## Addendum No. 2

DATE:	Monday, June 24, 2019
PROJECT:	City of Pharr/PSJA Aquatic Facility
PROJECT NO:	971805/ 1819-35-510-C011-051
LOCATION:	3001 N. Cage Blvd., Pharr, Texas 78577
FROM:	Laura N. Warren, The Warren Group Architects, Inc.

PROJECT DATE REVISED A1.11C ADD2 FLOOR PLAN-C

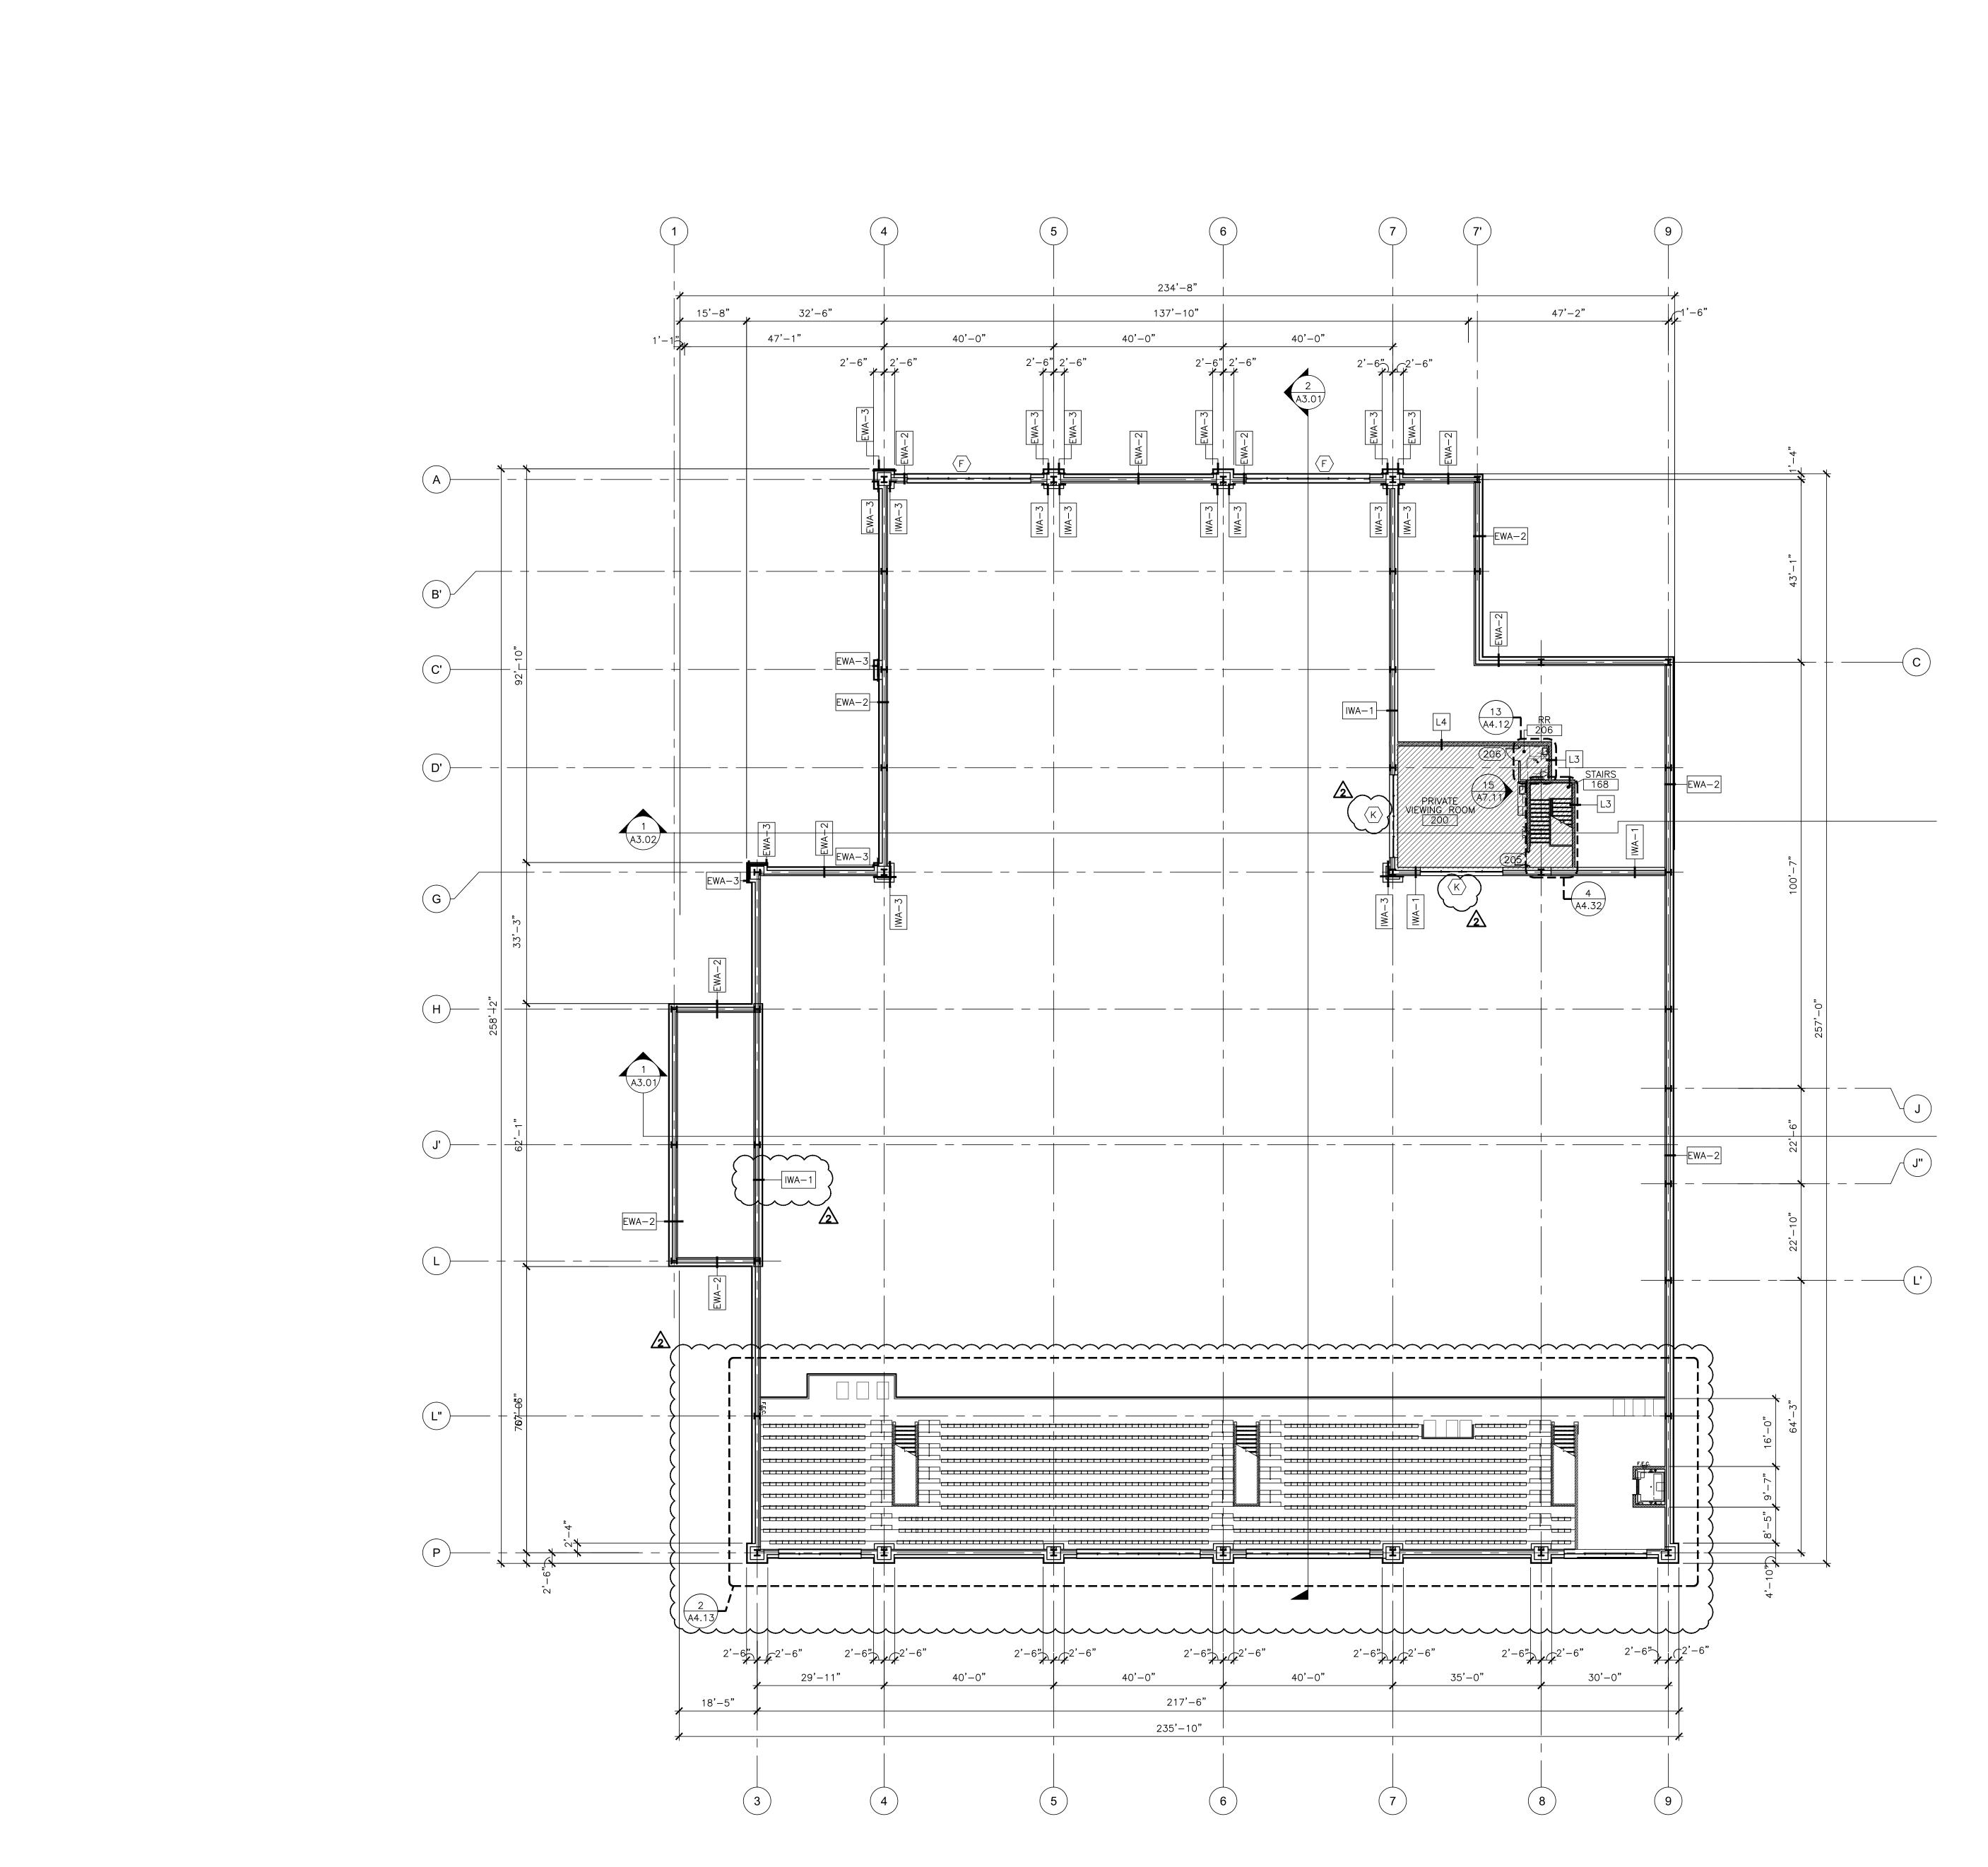
- Item No. 14: Refer to Construction Documents dated June 7, 2019. Plan details have been referenced. Refer to 30x42 sheets A1.11B and A1.11C ADD2 dated 6/21/2019.

A3.01 ADD2 **BUILDING SECTIONS**

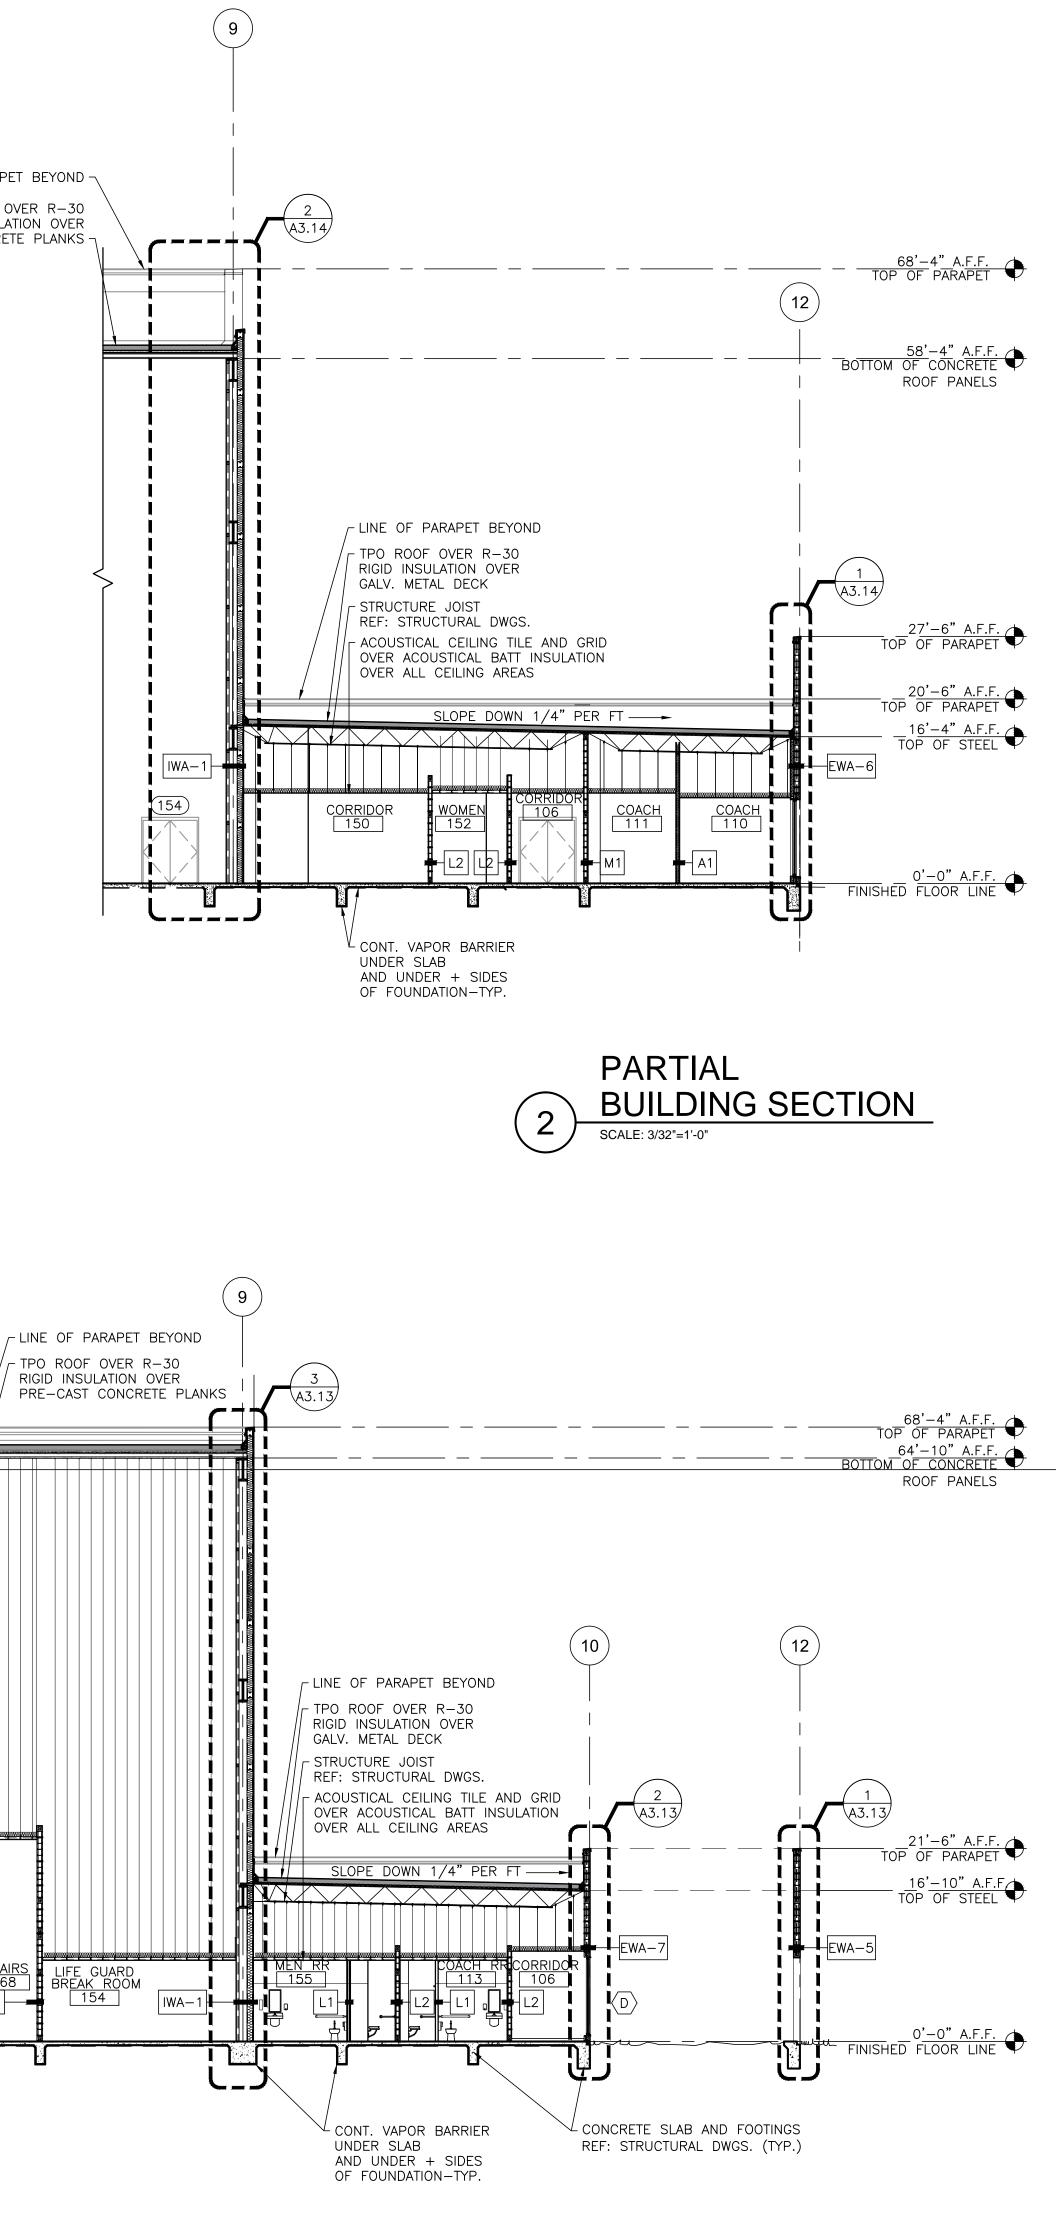
- Item No. 22: Refer to Construction Documents dated June 7, 2019. Additional sheet has been created. Refer to 30x42 sheet A2.13 ADD2 dated 6/21/2019.
- Item No. 23: Refer to Construction Documents dated June 7, 2019. Correct building heights have been noted. Refer to 30x42 sheet A3.01 ADD2 dated 6/21/2019.
